# Product *infos*

Document reference : PI9277

Subject : New SR2USB01 connecting cable

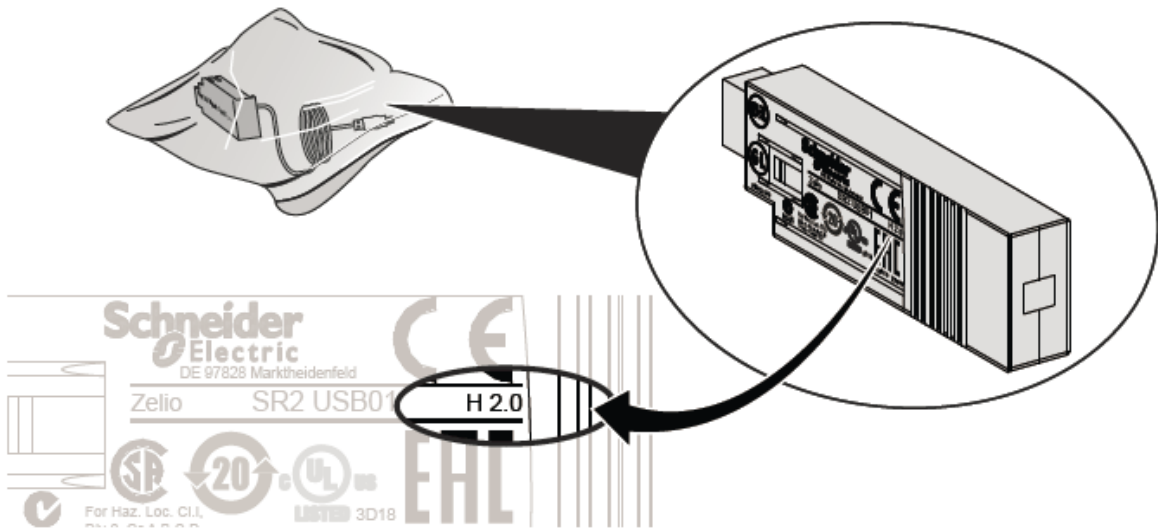
What happens if the customer do not install the new driver but uses the new cable ?

A message error will be displayed as soon as the customer tries to communicate the smart relay and the computer (error DC46\_10 or error DC46\_86).

Until the availability of Zelio Soft2 V5.1 (planned end of October for download, 1 month later for CD):

The customers may receive the new version of SR2USB01 cable but Zelio Soft2 V5.0 installation files do not include any suitable driver; the customers must download the new driver on Schneider-electric.com as indicated on the cable instruction sheet. Please note that this driver can be found by the most popular search engines : Google, Qwant, Yahoo, Bing, Ask ....

When Zelio Soft2 V5.1 will be available:

The driver will be included in the installation files and then easy to find by customers.
